CITY OF ATASCADERO DESIGN REVIEW COMMITTEE AGENDA

**Committee Meeting
Wednesday, September 25, 2019
2:00 P.M.**

2. DESIGN REVIEW OF NEW GAS STATION AT 9550, 9590 EL CAMINO REAL

Staff Report – Community Development Department

ANALYSIS:Site Design and Access.

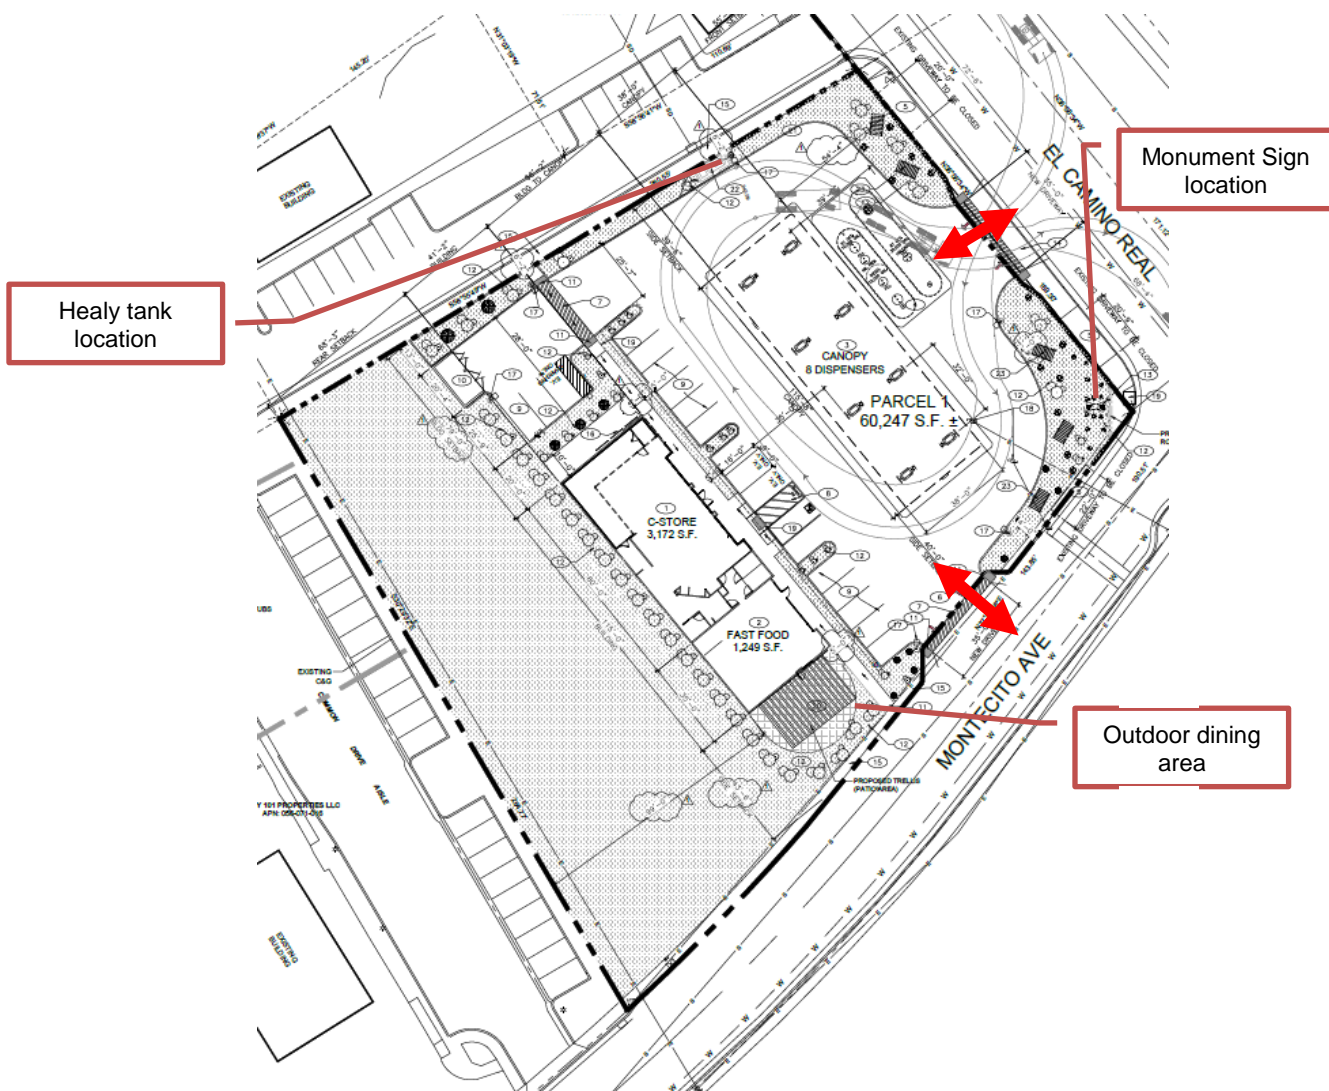
The development area will occupy approximately 0.9 acres, or 60%, of the site. The project area will include a new convenience store and restaurant, fuel dispenser canopy, and parking. The applicant has modified the site access to eliminate using the adjacent property improvements. The project is now accessed from 2 driveways: one approach along the eastern property line from El Camino Real; and one along the southern property line off of Montecito Avenue. The rear of the building is oriented to a portion of the site that is proposed to remain undeveloped. The building orientation does not activate this portion of the site and limits future integrated development.

In summary the building and parking area are inefficiently laid out on the site and leave a large portion of the site undeveloped at the back of the building. This strip of land will

be an ideal site for harboring transients, unauthorized storage, or simply a lack of maintenance. Staff suggests that the building be re-oriented to the corner, taking advantage of the entire site. The outdoor dining area for the restaurant could be expanded, or the site could have a more substantial landscape area or expanded retail store opportunity. ***The issue of the unplanned vacant area is the most substantial item for the DRC to provide input on.***

7. ***Modification of the site design to eliminate the attractive nuisance caused by orienting the rear of the building to a large undeveloped portion of the site.***

Side Elevations**Front Elevation – facing El Camino Real****Rear Elevation – Facing K-man and Tastee Freeze**

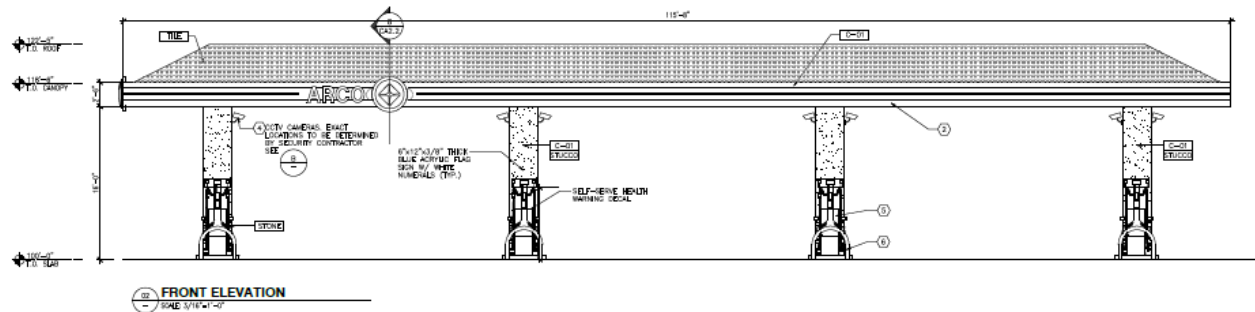
The overall design of the building remains a generic, corporate design, common to Arco fuel stations nationwide. In addition to wood-appearance panels and stucco, the applicant has included brick veneer consistent with local historic architectural materials. The main color theme consists of white and tan with medium toned wood accents. Tile roofs are proposed on tower elements. The primary façade facing El Camino Real includes white stucco exterior walls with 2 wood-look tower features and 2 stucco tower features with a darker tan. Storefront windows face El Camino Real and Montecito Ave. Contemporary steel awnings are proposed which will be accented in bright orange, consistent with corporate colors for AMPM. The brick veneer base is proposed to wrap the entire building and has been raised in height consistent with DRC's previous direction. The base is approximately 3 feet high under windows and increases to 8 feet in areas without windows. Two metal vine wall trellises are called out on the elevations facing the existing adjacent commercial center to the north. The proposed rear façade has minimal design features with no windows or public entrances.

Staff recommends the following modifications:

1. **Eliminate white from the stucco color palette and choose varying earth toned colors that are compatible with the Atascadero blend brick veneer.**
2. **Widen the wrapped parapet tower feature on the rear of the building and add a trellis/awning feature with landscaping.**
3. **Steel awnings should be black or dark grey in color.**

Attachment 5: Elevations
PRE 19-0034

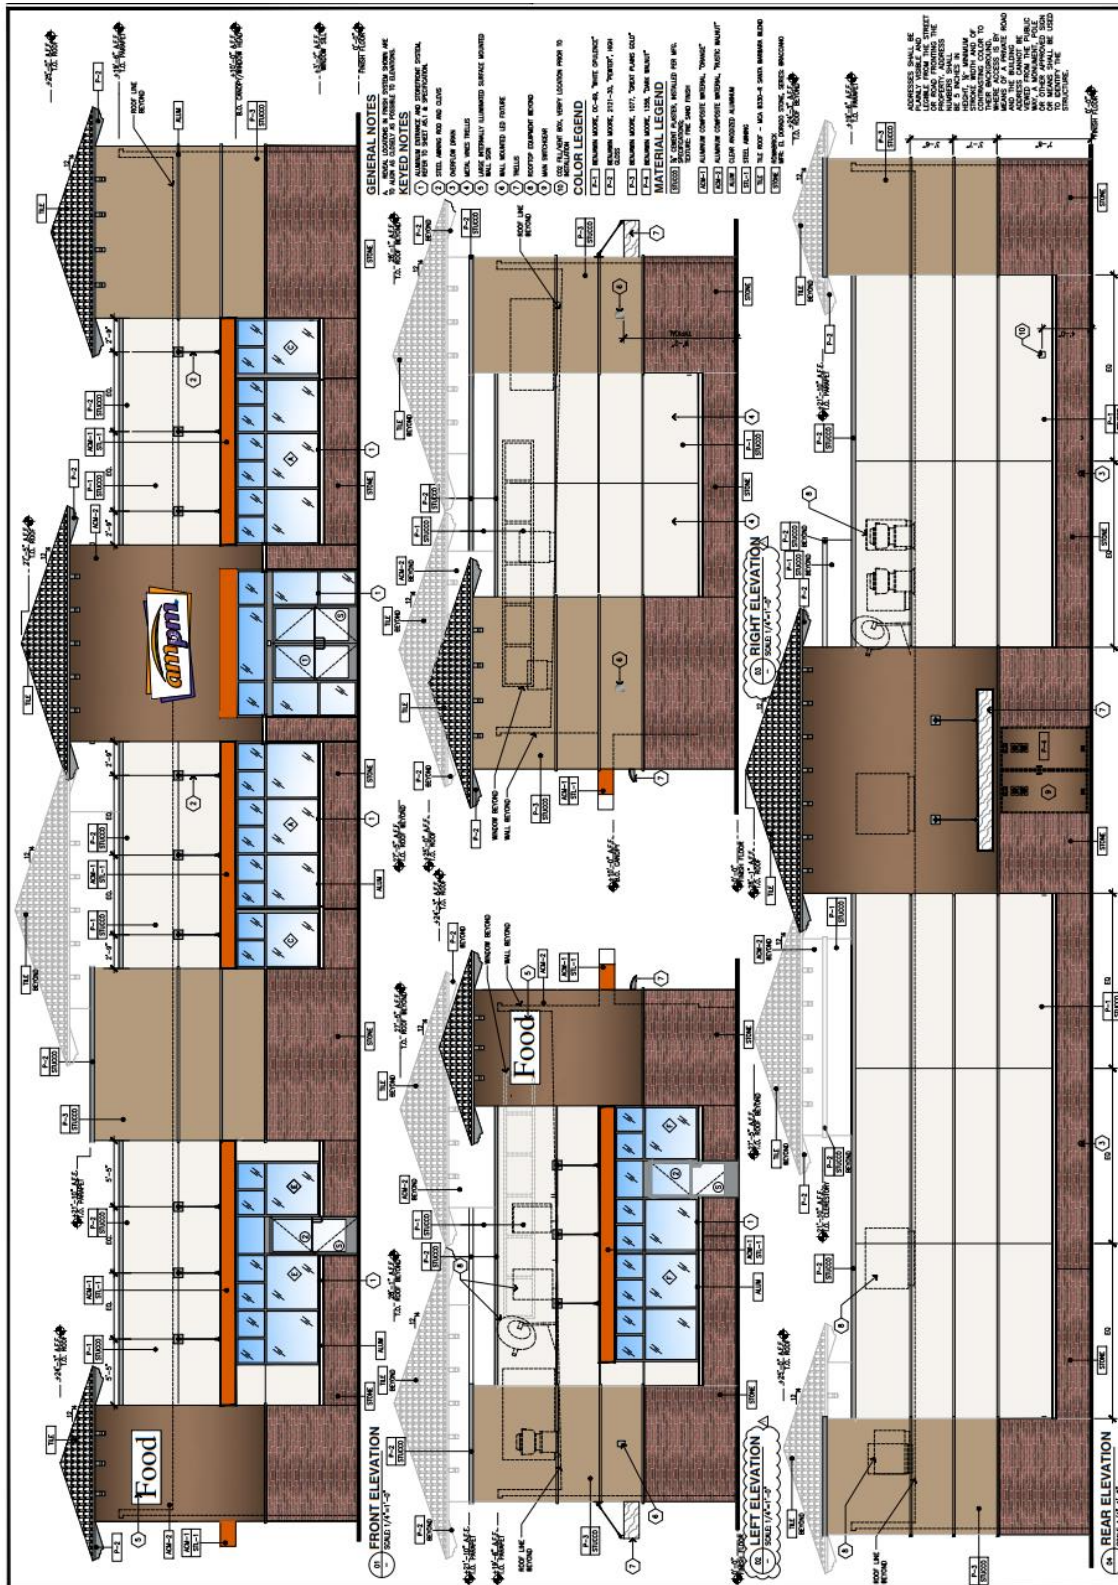
The canopy includes the ARCO name and logo on the sides facing El Camino Real and Montecito Ave. The logo hangs over, and protrudes above, the edge of the fascia. The canopy also includes color banding specific to the corporate colors. The banding is illuminated by a blue light.

- 1. Color banding on the canopy does not provide enhancement or consistency with the Mediterranean architectural style. Color banding and associated lighting strip should be eliminated.***
- 2. The canopy logo should be decreased to fit entirely on the fascia.***
- 3. Signage shall be permitted facing Montecito Ave for the restaurant tenant, provided that the total area for all tenant signage does not exceed 150 square-feet.***

13. Color banding on the canopy does not provide enhancement or consistency with the Mediterranean architectural style. Color banding and associated lighting strip shall be eliminated.

14. The canopy logo shall be decreased to fit entirely on the fascia.
15. Signage shall be permitted facing Montecito Ave for the restaurant tenant provided that the total area for all tenant signage does not exceed 150 square-feet.

Site Plan

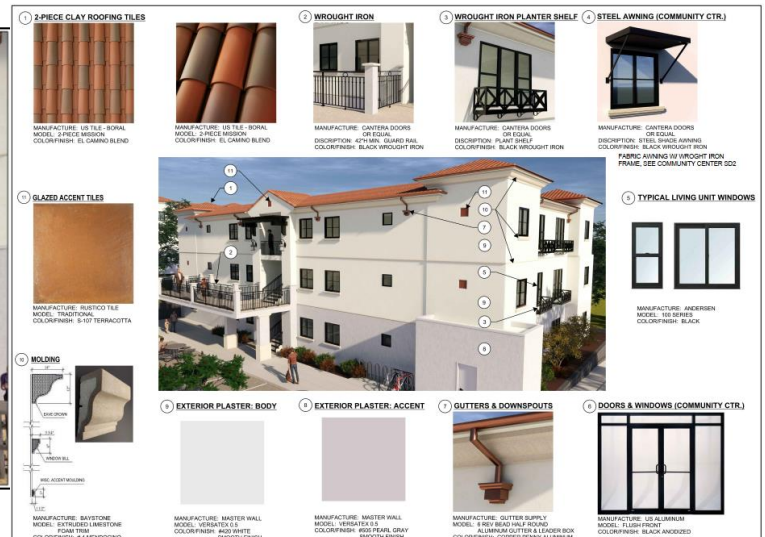
The buildings appear to blend when looking from El Camino Real as they utilize the natural slope and step up the hillside. The site is designed with a single access off El Camino Real. Four parking areas throughout the site allow for resident parking. Building #2 is set back 15 feet off the property line along El Camino. An existing driveway runs along the property line adjacent to the Del Rio Specific Plan area.

Due to the slope of the lot, retaining walls are to be added along the southern property line with a six-foot tall fence along the top. The combined height of fence and retaining wall could exceed 10 feet near or along the property line.

To reduce the visual impacts for neighboring properties, staff recommends that no retaining wall be over five feet tall. If the site requires taller retaining walls, the applicant should revise the plan to include shorter, tiered retaining walls.

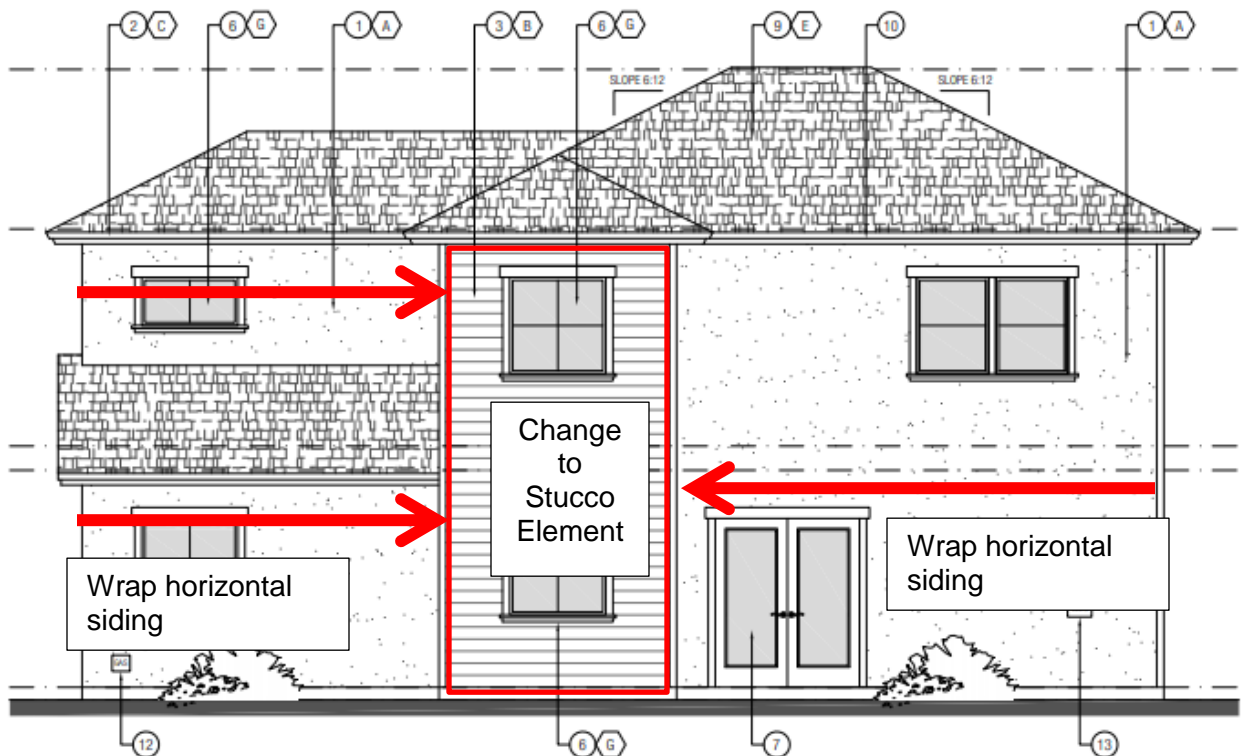
1. Horizontal siding on Option B wrap to the rear of the building and end at an inside corner (see diagram below)
2. Stucco be hand troweled smooth finish
3. Windows be high quality materials, not vinyl
4. Roofing be architectural grade dimensional composition shingles

COLOR SCHEDULE

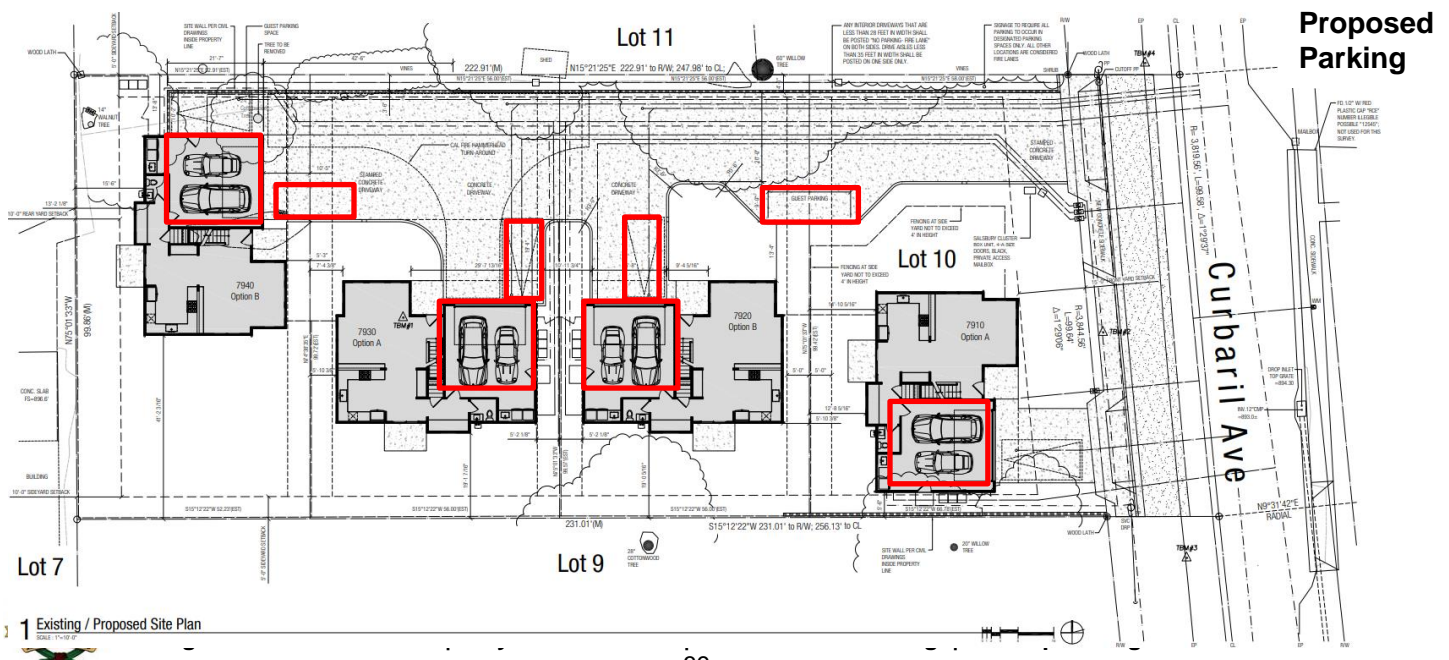
Staff recommends the following:

- A darker integral stucco color for color scheme A and tying the units together by using the same window and garage color for all 4 units.
- Use of historic color palettes for complimentary and accent colors
